Department
of Energy &
Climate Change

EMR Panel of Technical Experts' Final Report on National Grid's Electricity Capacity Report

June 2016

Figure 1 - ECR Figure 33: Comparison with original 2018/19 T-1 requirement (de-rated)

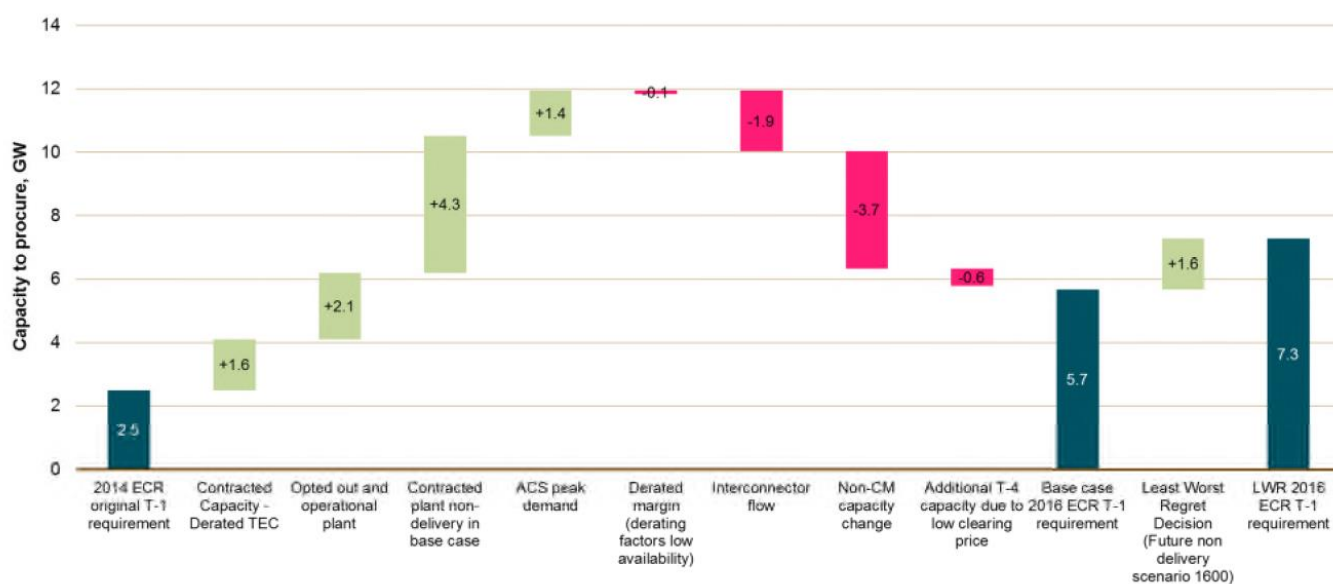
43. Figure 1 shows that there is a need to replace an anticipated shortfall of 2.1 GW of opted-out and operational plant that was expected to be present and was therefore deducted from the demand schedule in the 2014 auction. At least some of this plant has irrevocably closed and will therefore need to be replaced. In addition, apparently 4.3 GW of plant that secured capacity agreements has indicated that it may exit. Clearly if it does exit it will need to be

44. We note that in the 4.3 GW of existing contracted plant that may fail to deliver, 1.6 GW is the CCGTs from the first auction and that is more than offset by the interconnectors providing an estimated 1.9 GW (although National Grid have not made an assumption about the contribution at peak).
45. The results of the 2017/18 auction will therefore be important in estimating what existing plant is kept on the system and available to bid into the T-1 2018/19 auction.

Figure 3 - Average Capacity Value as a function of Interconnection Capacity

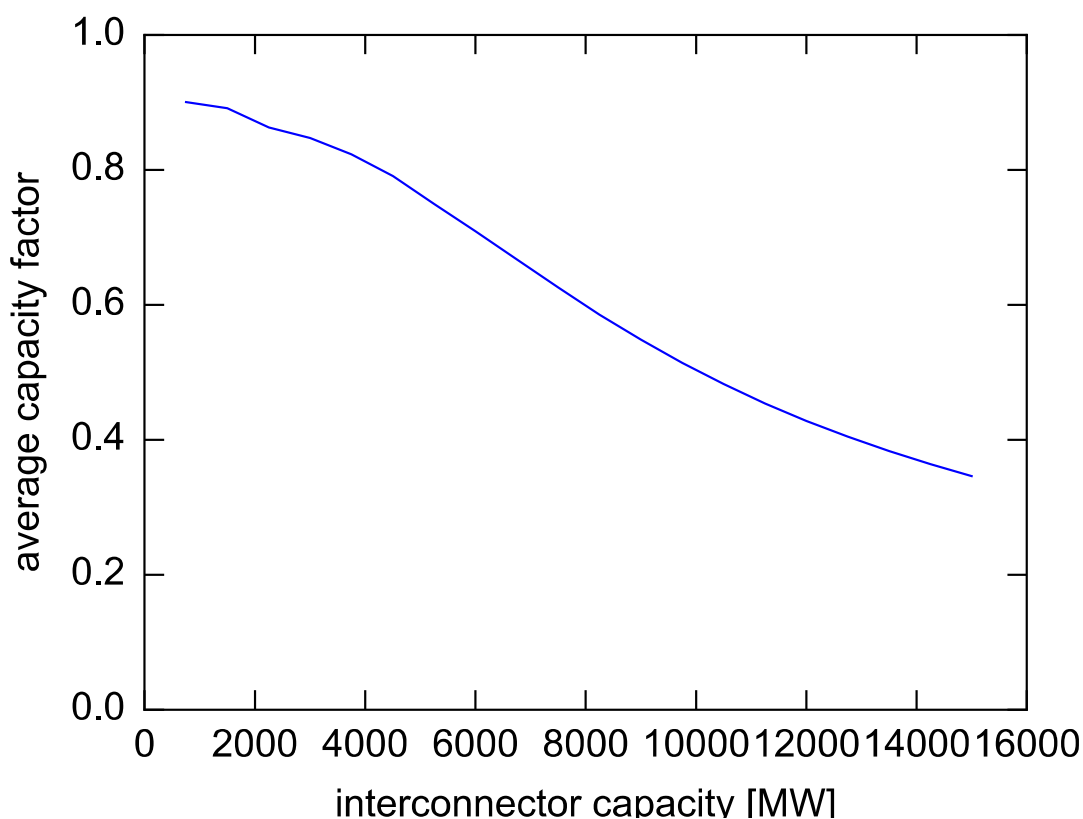
74. Figure 3 suggests that increasing interconnector capacity will lead to a reduction in the de-rating as interconnection capacity increases and the saturation effect begins to manifest. For the auctions that are the subject of the 2016 ECR, however, the analysis also shows that the saturation effect can be discounted, as levels of interconnection to each country are lower than sizes highlighted in the above. In the future, as GB interconnection to continental Europe increases, this effect could be incorporated into the analysis. The saturation effect should, however, be included in the Pan-European model development. (See paragraph 133 in this report for more detail on the Pan-European modelling).

Figure 4 - Role of Scarcity Pricing to Incentivise DSR and Avoid Expensive Loss of Load

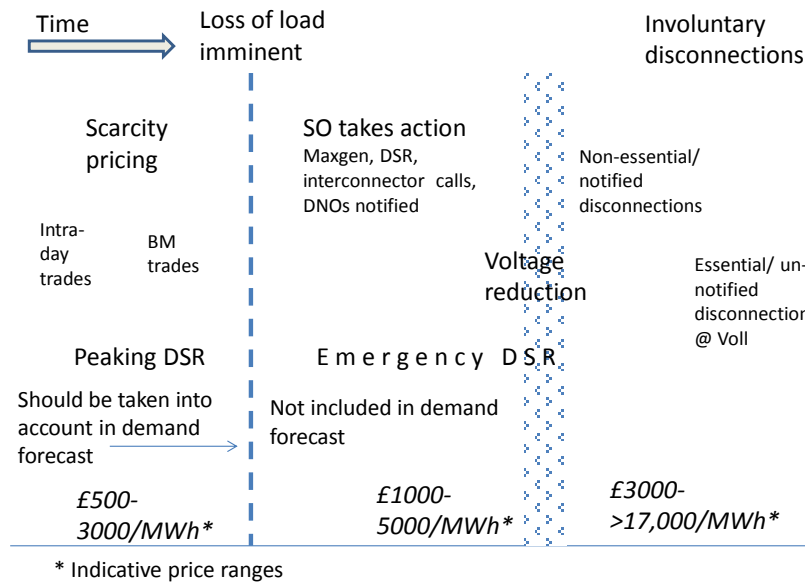
105. Figure 4 illustrates how scarcity pricing, at much lower cost than VoLL, should incentivise peaking DSR to avoid loss of load events occurring and conversely, that the suppression of scarcity prices will underutilise the DSR response leading quickly to more expensive mitigating action taken by the System Operator which would be classified as an emergency measure and therefore a loss of load event.
